# **Nantucket Memorial Airport Master Plan Update**

## **Appendix 7– Modification to Standards 85 & 86**

NEW ENGLAND REGION  
WAIVER OF AIRPORT STANDARDS  
(or Deviation)

Deviation Summary: Parallel Taxiway Separation Requirements

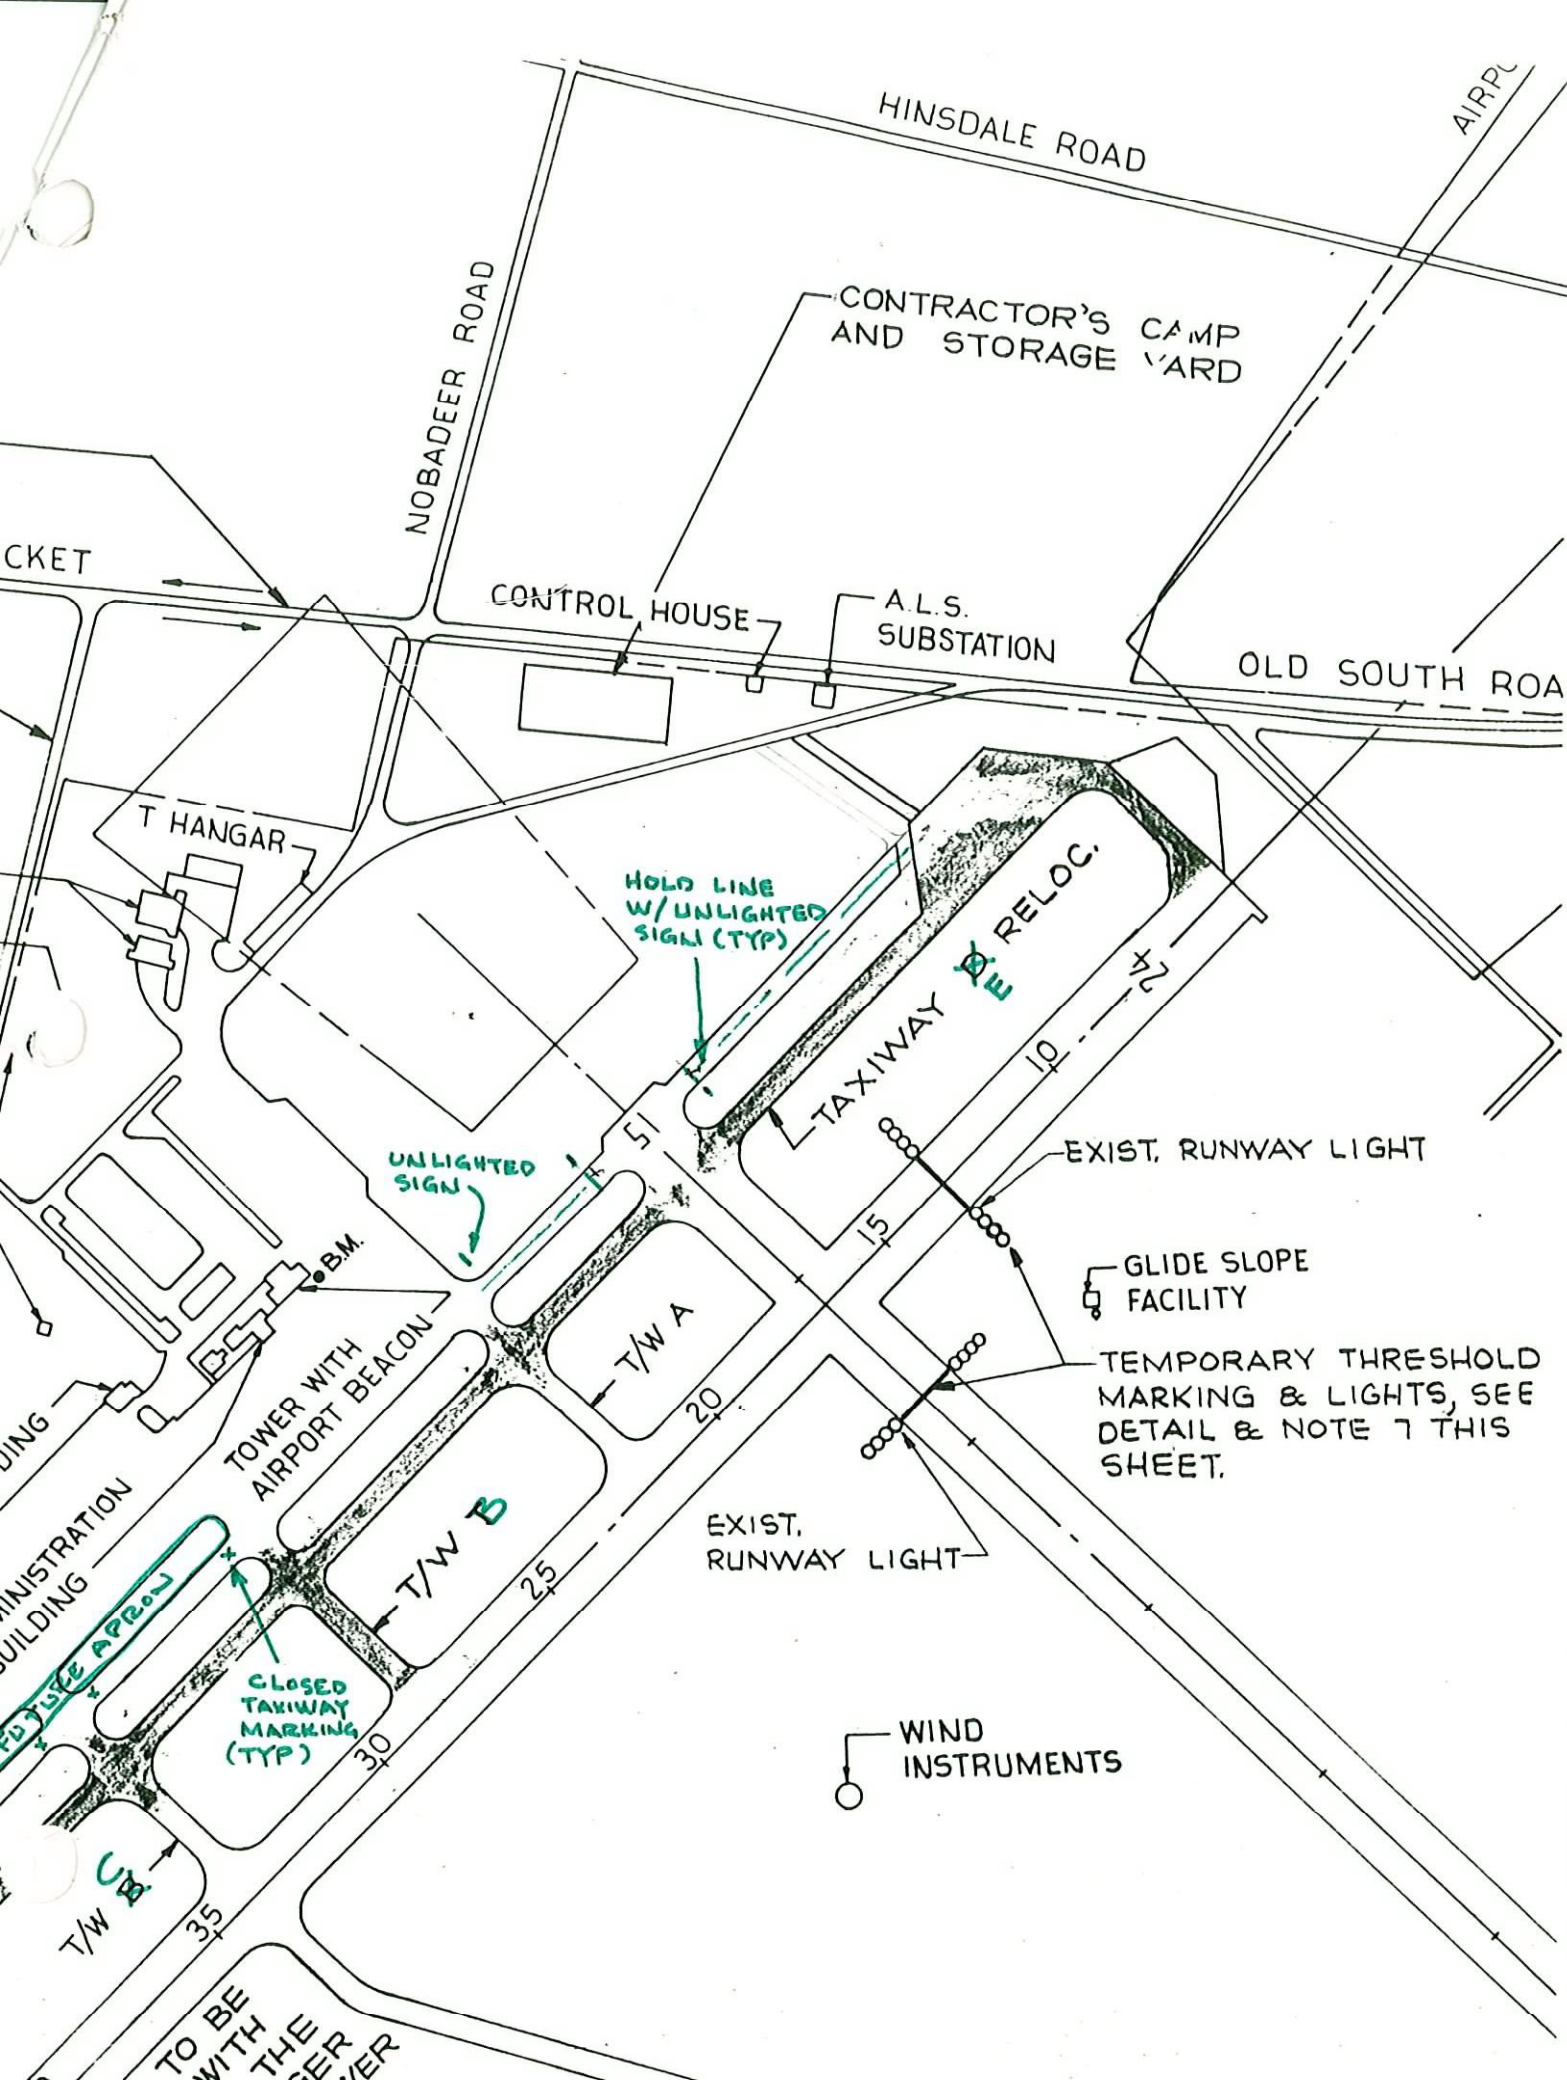
Also, the airport receives occasional use by B-727, in a non-commercial capacity. Advisory Circular 150/5300-12, Airport Design Standards - Transport Airports, requires 153' separation between parallel taxiway centerlines for Group III aircraft (wingspan between 79' and 118'). The separation between the new taxiway and existing taxiway is 125'.

Airport use by Group III aircraft is not frequent, however it is conceivable that parallel operation by large aircraft could occur which would present a potential hazard. To prevent this possibility, although remote, certain restrictions will be required on the use of the existing taxiway.

The attached sketch shows a typical section with the pertinent clearance limits noted for reference.

It is recommended that a waiver of parallel taxiway separation criteria be granted subject to the following restrictions:

1. Use restricted by direction of Air Traffic Control.
2. Use restricted to daylight only.
3. Use restricted to small airplanes (maximum gross weight  $\pm$  12,500 pounds).
4. Marking, in accordance with AC 150/5340-1E, be provided by the sponsor with the exception that guidance signs be unlighted.
5. Existing lighting circuit be discontinued as proposed under the taxiway extension project.

6. Sponsor will submit a plan for marking and signing for approval by the FAA.
7. If eligible, the airport sponsor will coordinate with ATCT to publish an airport diagram with suitable restriction notation in the Instrument Approach Procedures publication and the Airport/Facility Directory.
8. Grading requirements, as specified under Taxiway Safety Area in AC 150/5300-12, shall be maintained.

NANTUCKET MEMORIAL AIRPORT  
 WAIVER OF MINIMUM PARALLEL TAXIWAY  
 SEPARATION CRITERIA

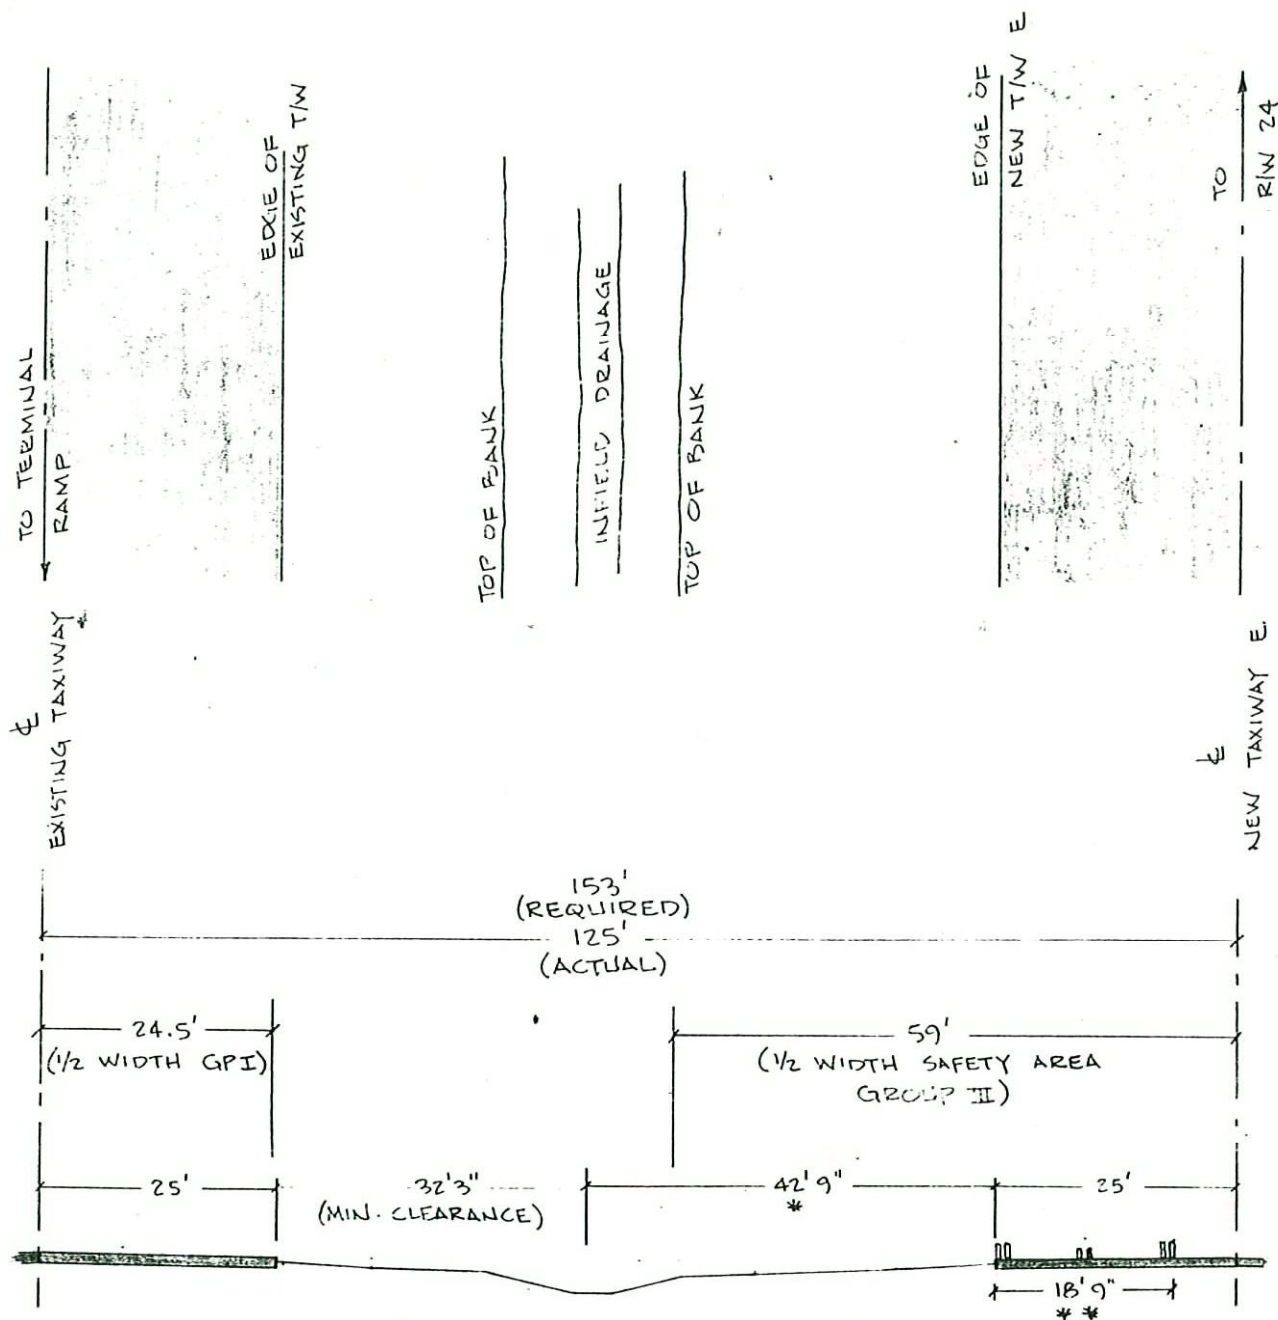
Deviation: Reduce separation from 153' centerline to centerline  
to 125' centerline to centerline.

Justification: New parallel taxiway extension is sited 400' from  
runway 6-24 centerline. This is 125' from centerline  
of existing partial taxiway. Maintaining both  
taxiways will allow more flexibility for flow control  
by ATCT. Existing taxiway will be restricted to small  
aircraft.

HOLD LINE W/ UNLIGHTED SIGN (TYP)

UNLIGHTED SIGN

CLOSED TAXIWAY MARKING (TYP)
